SB, Gearbox locking pin, FS5000, FS7000, 3-speed gearbox, 2025-03

SYMPTOM/DESCRIPTION

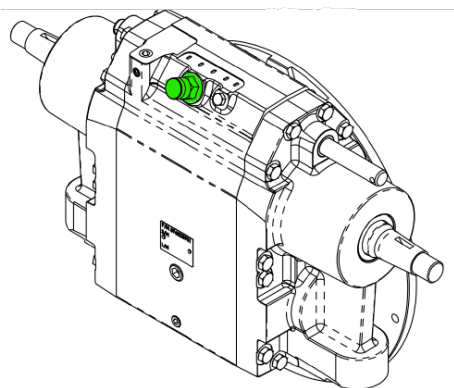
The locking pin with counter nut on the 3-speed gearbox must not be overtightened, there is a risk that over time and together with vibrations, the screw will break. The correct procedure when securing the selected gear is to tighten the locking pin finger-tight and then tighten the counter nut with a tool and the lowest possible torque. This must not supersede 50Nm.
